Evaluation of Physical Barriers - South Perris Station

Address: South Perris Blvd, Perris, CA 92570

Evaluation Date: 08-06-2021

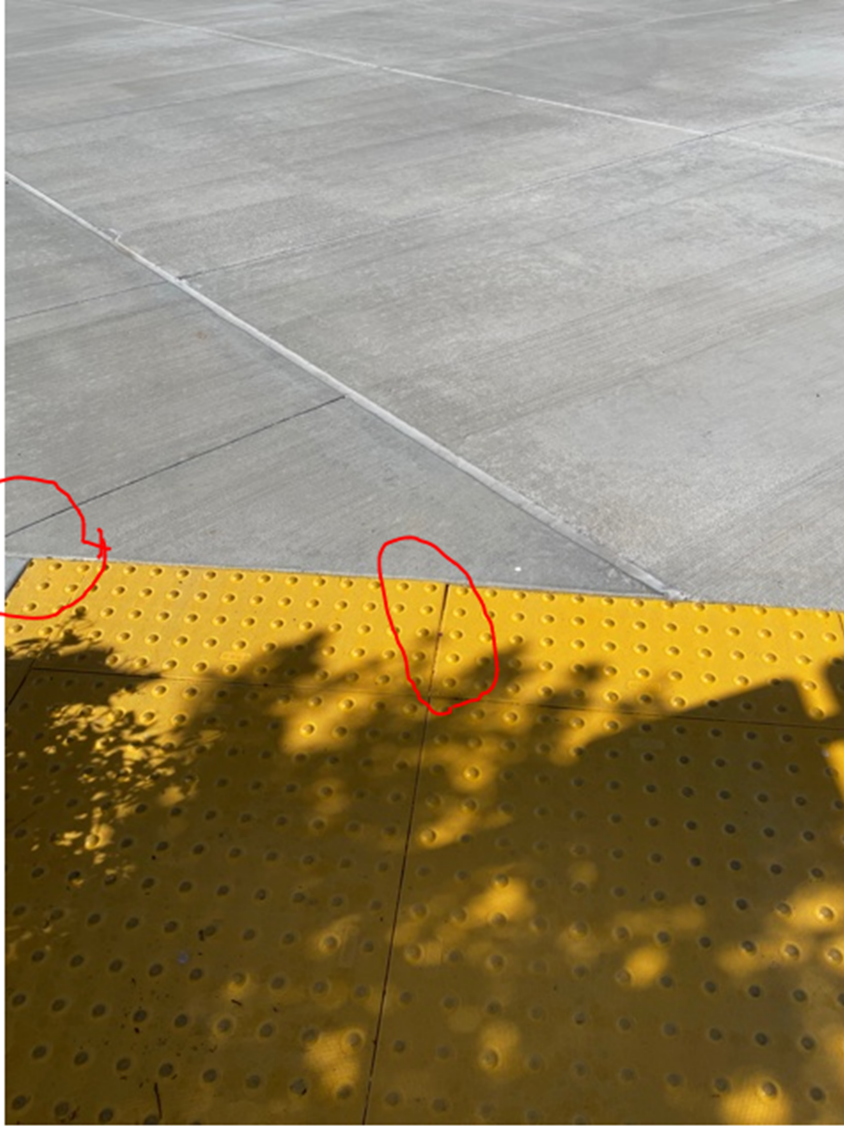
Issues	Recommendations	Comments
<div>1. Curb Ramps</div> <div>1a, 1b, 1c - OK 2a, 2c – OK 2b- Trip hazard due to level change in Detectable Warning Surface (DWS) tile.</div> <div></div>	<div>See Item 3 below</div>	<div>Curb ramps are labeled on page 1</div> <div><p>Figure 406.2 Counter Slope of Surfaces Adjacent to Curb Ramps</p></div> <div><p>This evaluation does not include curb ramps outside the RCTC boundary. RCTC is not responsible for maintaining the accessible routes outside of RCTC boundary.</p><p>When repairs begin, use proper and precise instruments (4-foot smart level and 2-foot smart level) to fit within the curb ramp width and the adjacent gutter to measure ramp slopes, cross slopes, and counter slopes at all curb ramps (all stations). The long slope of ramp shall not exceed 1:12 (8.33%). Slope of flared sides shall not exceed 1:10 (10%), the gutter slope shall not exceed 1:20 (5%). Cross slope of the ramp and landing shall not exceed 1:50 (2%)</p><p>Use smart level instruments, calibrated in accordance with manufacturer’s instructions before taking measurements.</p></div>

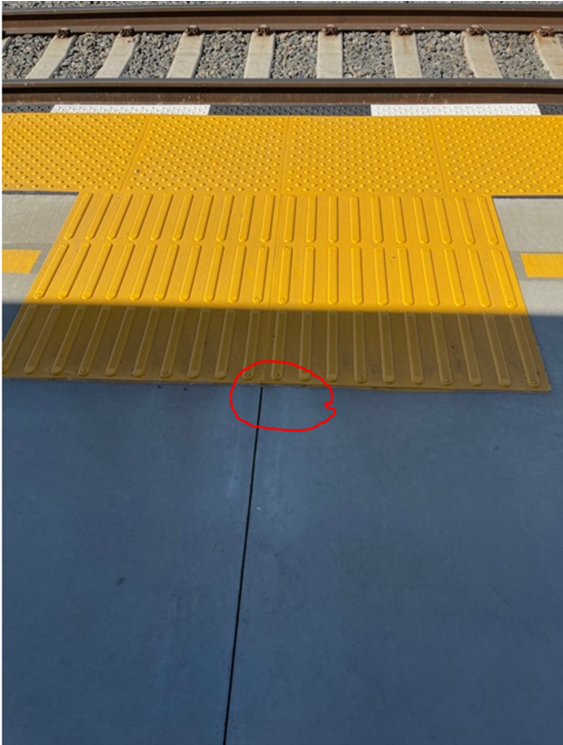
a) Pedestrian Push Button- Not Applicable	No action by RCTC	
3. Accessible Routes		
a) Walking surface		
<p>Aisles at the ADA parking spots have major cracks, level changes, and gaps. The asphalt has separated from the concrete causing gaps wider than an inch. The parking spaces are not accessible due to these issues.</p>  	<p>Examine all parking aisles, accessible routes and repair all cracks.</p> <p>Every joint deeper than $\frac{1}{4}$" and wider than $\frac{1}{2}$" shall be filled.</p> <p>Every level change along the accessible route greater than $\frac{1}{4}$" and less than $\frac{1}{2}$" height needs to be beveled (1:2) slope or repaired.</p> <p>Every level change greater than $\frac{1}{2}$" needs to have a ramped surface (1:12) slope.</p>	 <p>Figure 302.3 Elongated Openings in Floor or Ground Surfaces</p>  <p>Figure 303.3 Beveled Change in Level</p>  <p>Figure 303.2 Vertical Change in Level</p>

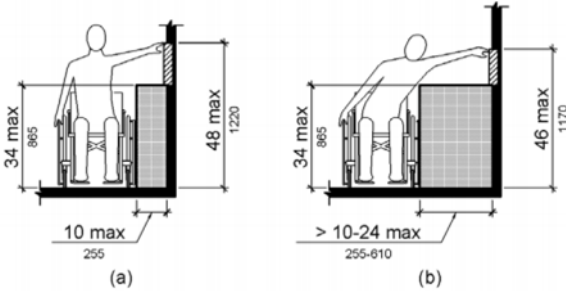
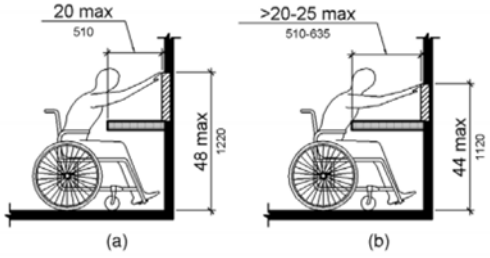
<p>Cracked concrete at drop off zone.</p> 	Same as above
